INSERTION INSTRUCTIONS FOR AMENDMENT 5

BVPS-2 ER-OLS

NRC QUESTIONS AND RESPONSE INDEX

FIGURE 7.1-5  
POINT ESTIMATE RISK CURVE FOR  
THYROID CANCER FATALITIES  
BEAVER VALLEY POWER STATION-UNIT 2  
ENVIRONMENTAL REPORT  
OPERATING LICENSE STAGE

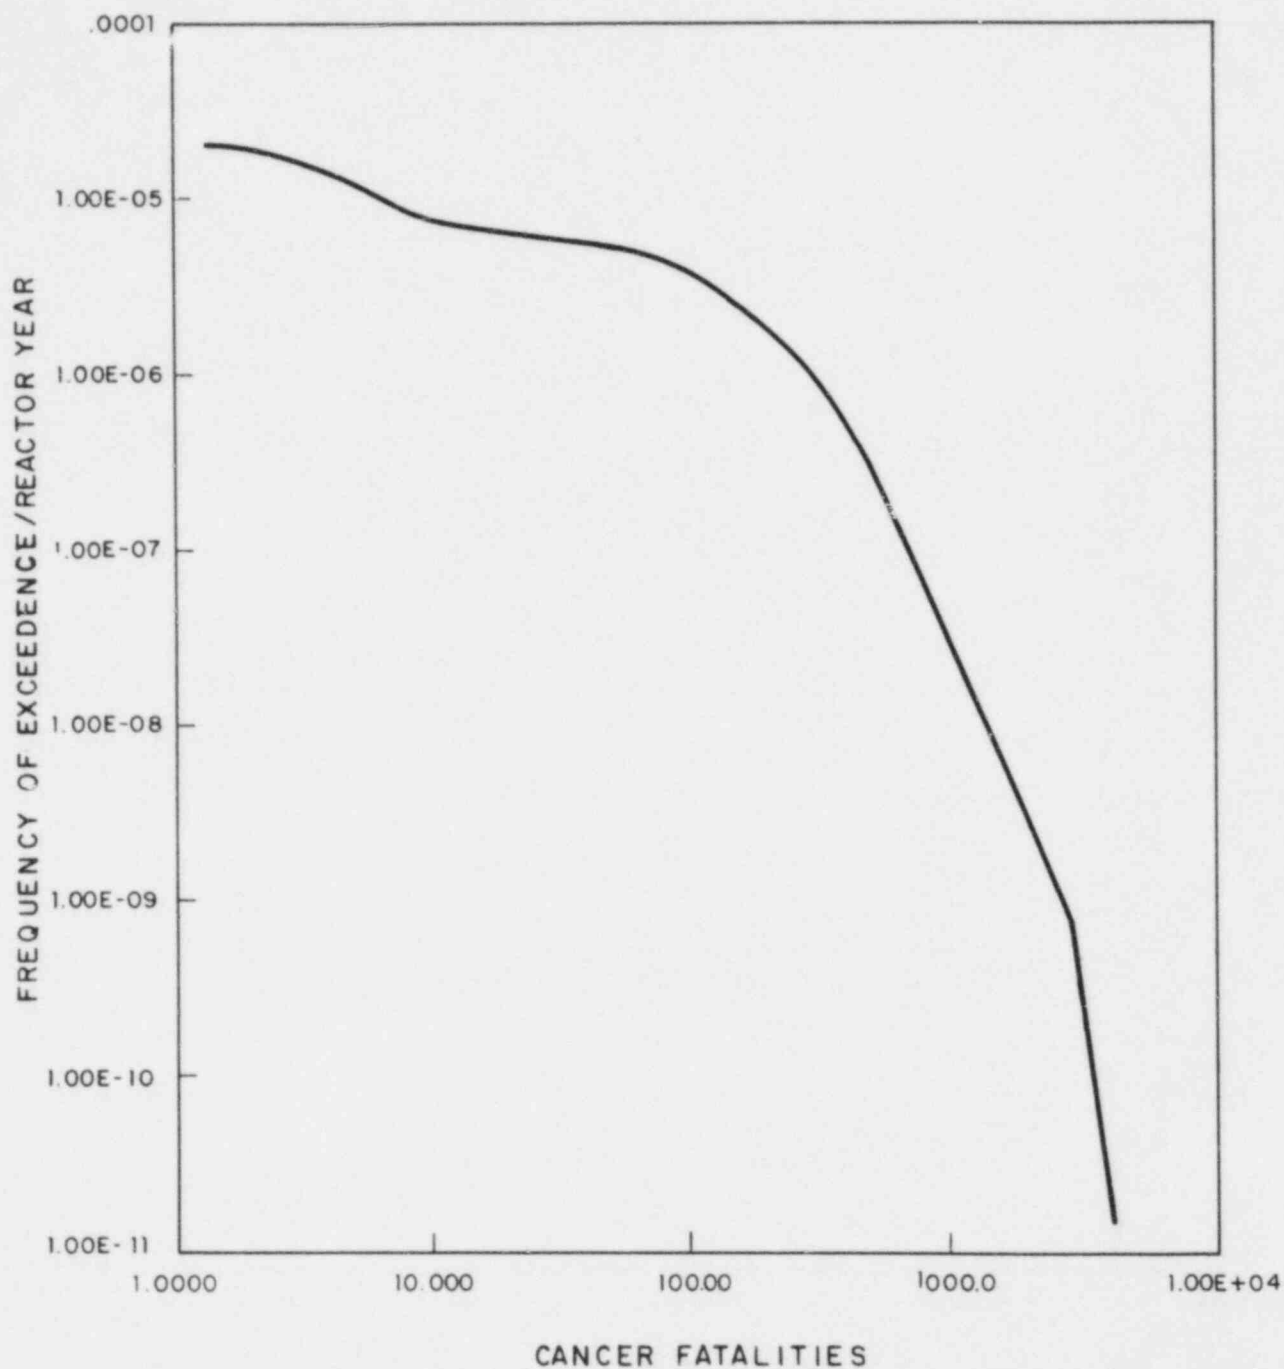
- a. Your use of the population data for the year 1980, instead of the data for the plant mid-life year, is consistent with the staff's practice. Please provide basis for your selection of this population data; and
- b. Information regarding the following items are absent in ER-OL:
  - i. Risk estimates to an individual of early fatality as a function of distance or as isopleths,
  - ii. Probability distribution and risk estimates of thyroid cancer fatalities,
  - iii. Estimated person-rem and cancer fatalities (excluding thyroid, and thyroid only) CCDFs and risks within the 50-mi region,
  - iv. Estimated distributions of number of persons exposed above 25 rems to whole-body, 300 rems to thyroid, and 200 rems to total bone marrow from early exposure, and
  - v. Estimated economic cost of damage to the plant.

- b. (ii) The risk curve for thyroid cancer is provided on Figure 7.1-5, Amendment 5.
- b. (iii) Generation of risk curves for the population within 50 miles of BVPS-2 requires an additional set of CRAC runs. The additional information gained by performing these analyses does not warrant the additional effort required.
